# Sundry Print Report

Well Number: 277H

Well Name: COTTON DRAW UNIT Well Location: T25S / R31E / SEC 13 / County or Parish/State: EDDY /

**Notice of Intent**

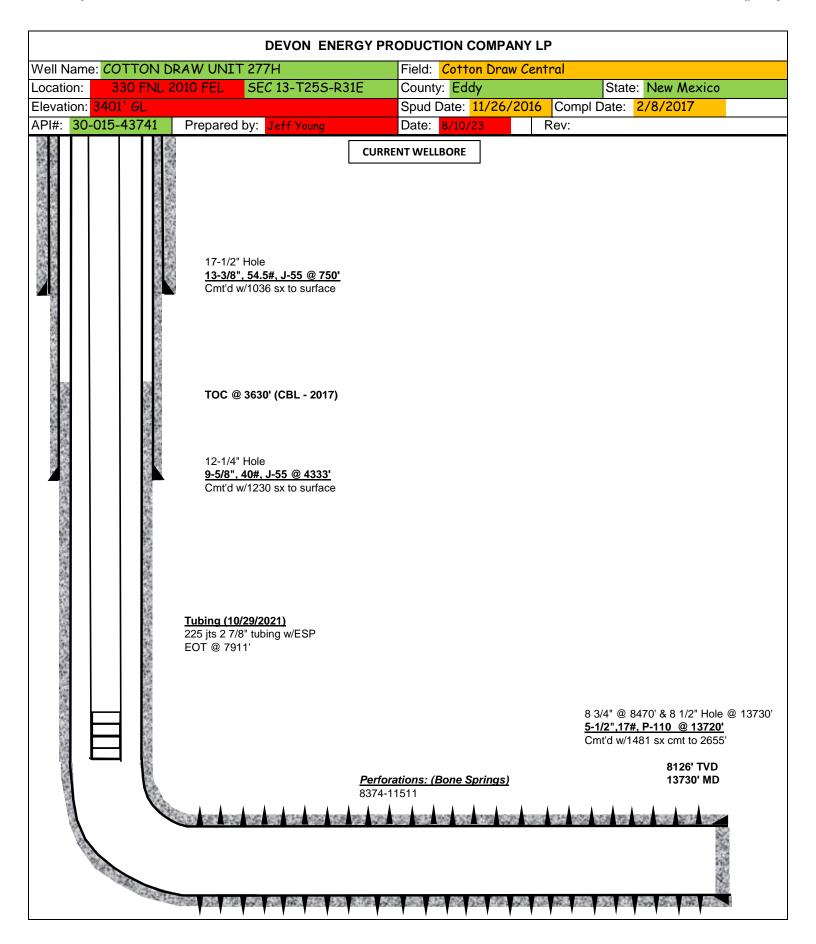
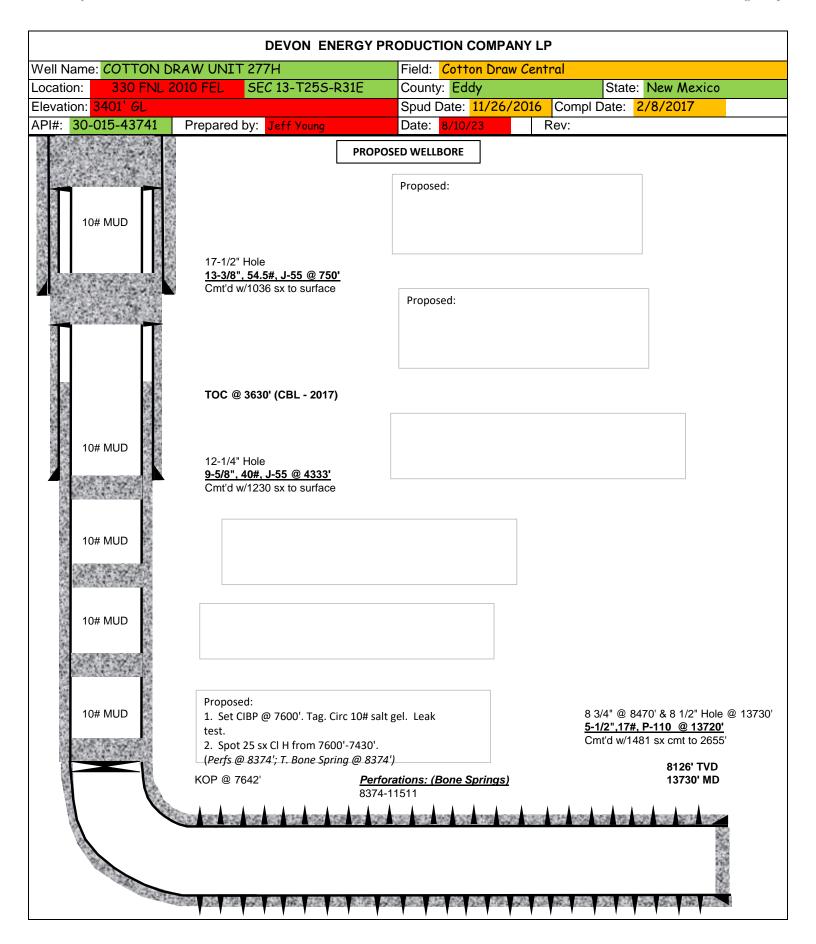
Sundry ID	2745568	-					
						Cement	
Plug Type	Тор	Bottom	Length	Tag	Sacks	Class	Notes
Surface Plug	0.00			Tag/Verify	Oucks	Oluss	Notes
Fresh Water @ 720	662.80	770.00	107.20

692.50						
Shoe Plug	092.50	600.00	107.50	Tag/Verify			Daufanata and
							Perforate and
							squeeze from 1063'
							to surface. (In 106
							sxs/Out 210 sxs)
Top of Salt @ 1005	944.95	1063.00		Tag/Verify	316.00	С	Verify at surface.
Base of Salt @ 4154	4062.46	4204.00	141.54	Tag/Verify			
Shoe Plug	4239.67	4383.00	143.33	Tag/Verify			
, and the second				<u> </u>			
				l <b>f</b> = =1; =1			
				If solid			
				base no			
				need to			
				Tag (CIBP			
				present			
				and/or			
				Mechanic			
				al Integrity			
				Test), If			
				Perf &			
				Sqz then			
				Tag, Leak			
				Test all			
				CIBP if no			
				Open			Spot cement from
				Perforatio			4374' to 4154'. WOC
Delaware @ 4374	4280.26	4424.00	143.74	ns	25.00	С	and Tag.
KOP @ 7642	7515.58	7692.00	176.42	If solid			
				If solid			
				base no			
				need to			
				Tag (CIBP			
				present and/or			
				Mechanic			
				al Integrity			
				Test), If

Perf &			
				Sqz then			
				Tag, Leak			
				Test all			
				CIBP if no			
				Open			Set CIBP at 7600'.
				Perforatio			
CIPD Dive	7505.00	7000 00	05.00		05.00		Spot 25 sxs on top.
CIBP Plug	7565.00		35.00		25.00	П	Leak Test CIBP.
Shoe Plug	13532.80	13770.00	237.20	Tag/Verify

No more than 2000' is to be allowed between plugs in open hole, and no more than 3000' between plugs in cased hole.

Fluid used to mix the cement in R111P shall be saturated with the salts common to the section penetrated, and in suitable proportions, but not more than 3% calcium chloride by weight of cement will be considered the desired mixture whenever possible.

High, Critical: Bottom of Karst to surface or Deepest fresh water, whichever is greater R111P: 50 Feet from Base of Salt to surface.
